Responses from the Applicant's team in blue bold text
January 12, 2024
(Responses starting on page 4)

TO: Hopewell Township Planning Board
FROM: Mark Kataryniak, PE, Township Redevelopment Engineer
DATE: November 10, 2023
SUBJECT: **Engineering Review 1**
Preliminary & Final Amended Major Site Plan
Hopewell Parc Apartments – Phase 1N-4
1 SP Drive Owner Urban Renewal LLC
Block 93.06 Lots 81 & 83, IMF-1 Zone
Hopewell Township, New Jersey
FEI Project No.: 23HT205

COMMUNITY SIGNAGE

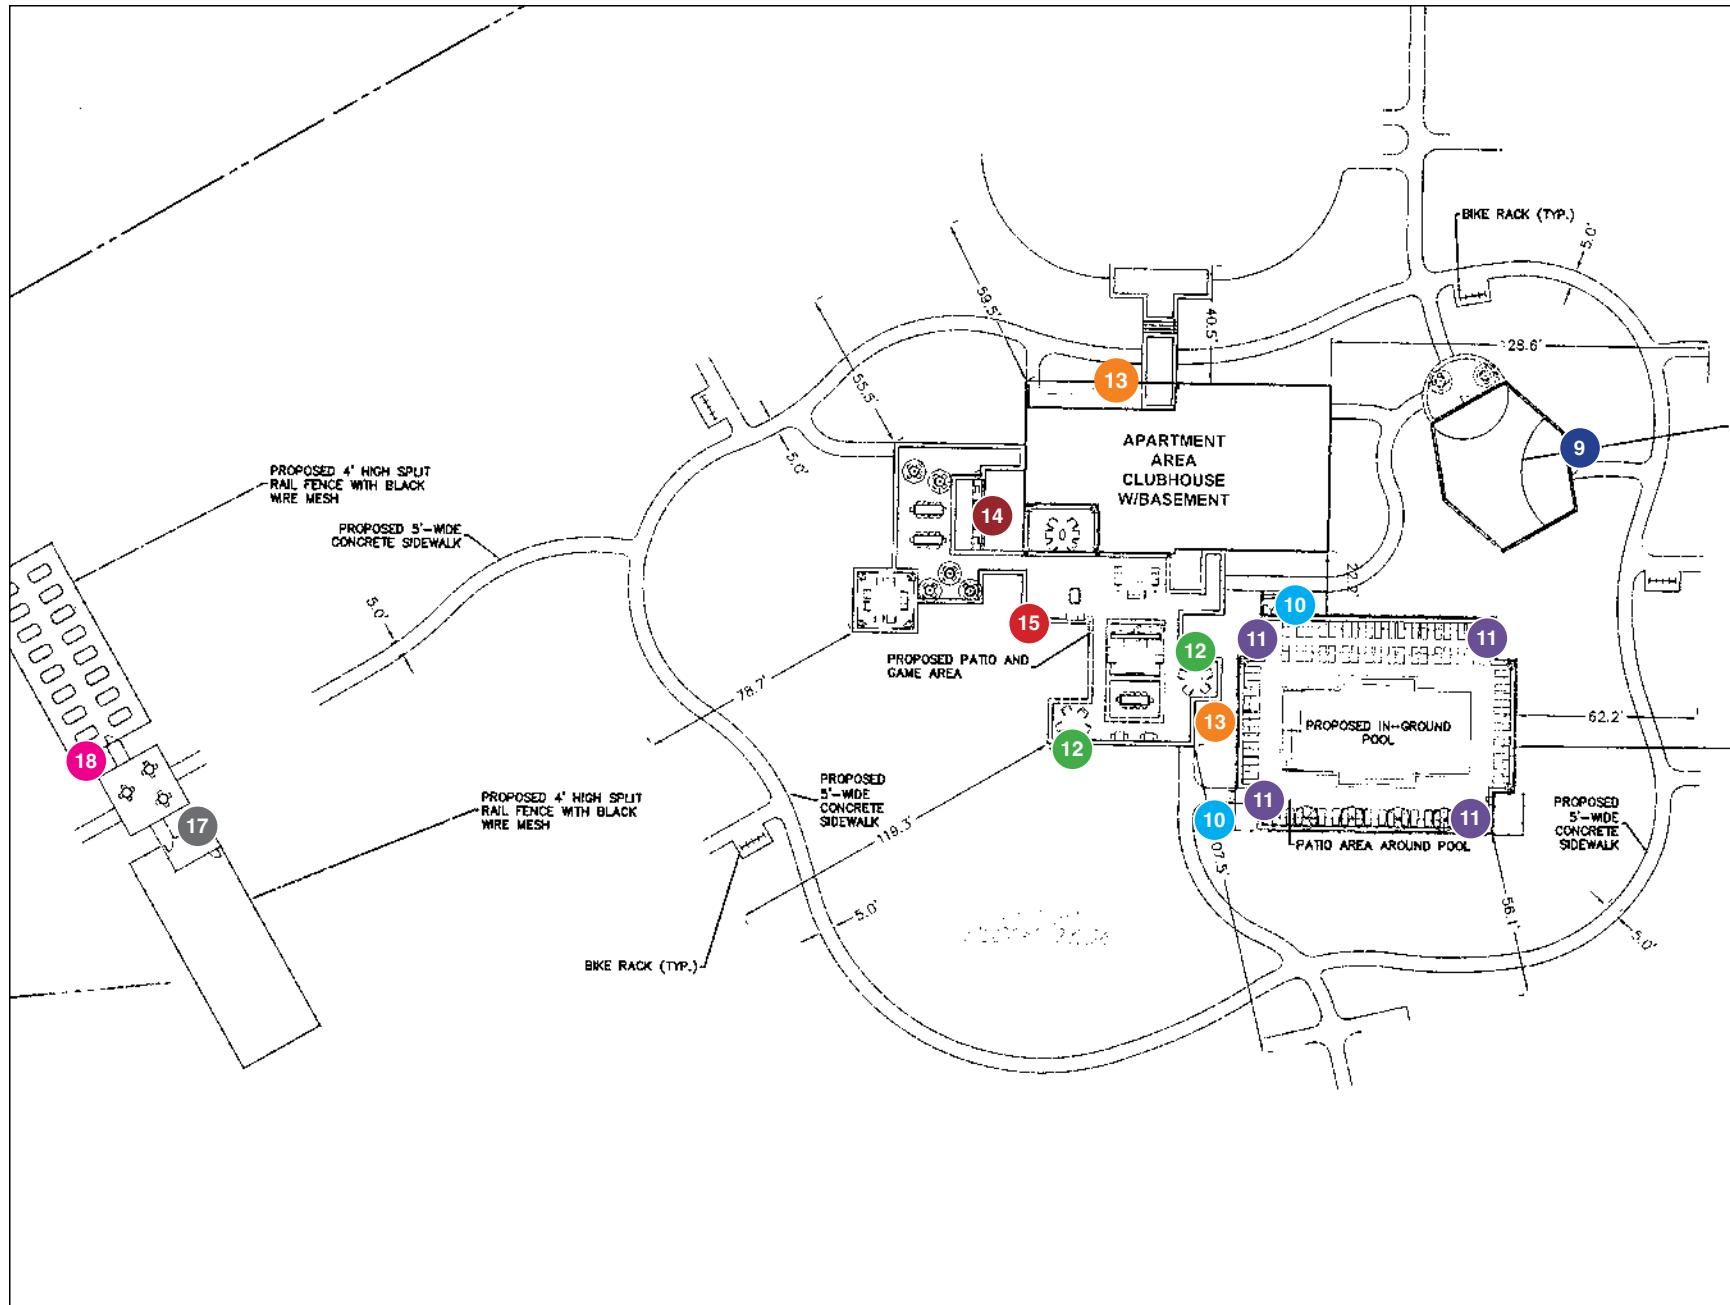
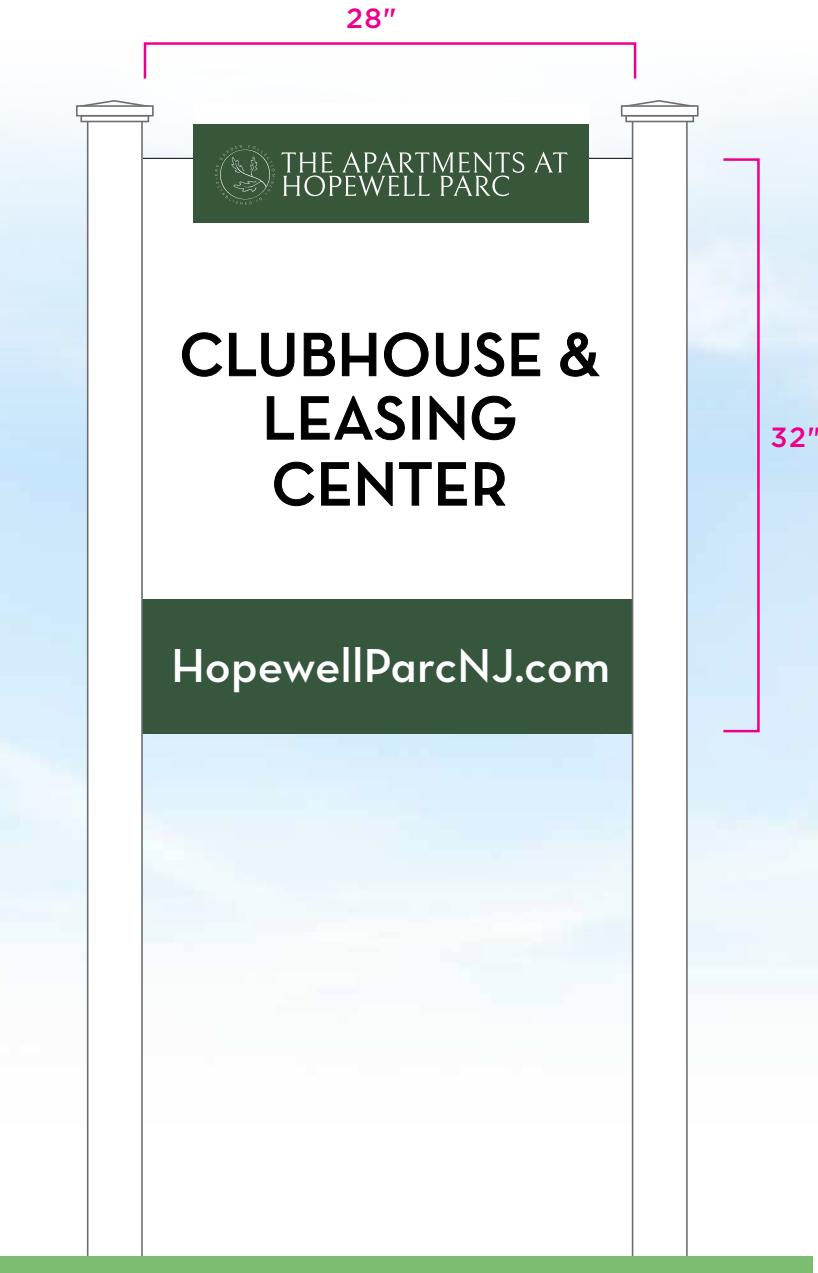
- a. Total sign area; 25 square feet permitted; $24.29\pm$ square feet proposed
- b. Sign height; 5 feet permitted; 3'9" proposed
- c. Curbline setback; 10 foot minimum required; >10 feet proposed
- d. Sign Lighting (per §17-106.d10); Shielded light source from adjoining or nearby lots, streets, and interior drives required; applicant shall provide details on the proposed sign lighting to demonstrate compliance with this section of the Ordinance.

- a. A dimension should be added to the plan showing the setback of the proposed site identification sign to the right of way and curbline of Aaron Truehart Way.

Response: Lighting is shown on the Entry Monument Sign and section provided.

Please refer to Attachment A for further detail on signage.

Response: A dimension will be added at the requested location.
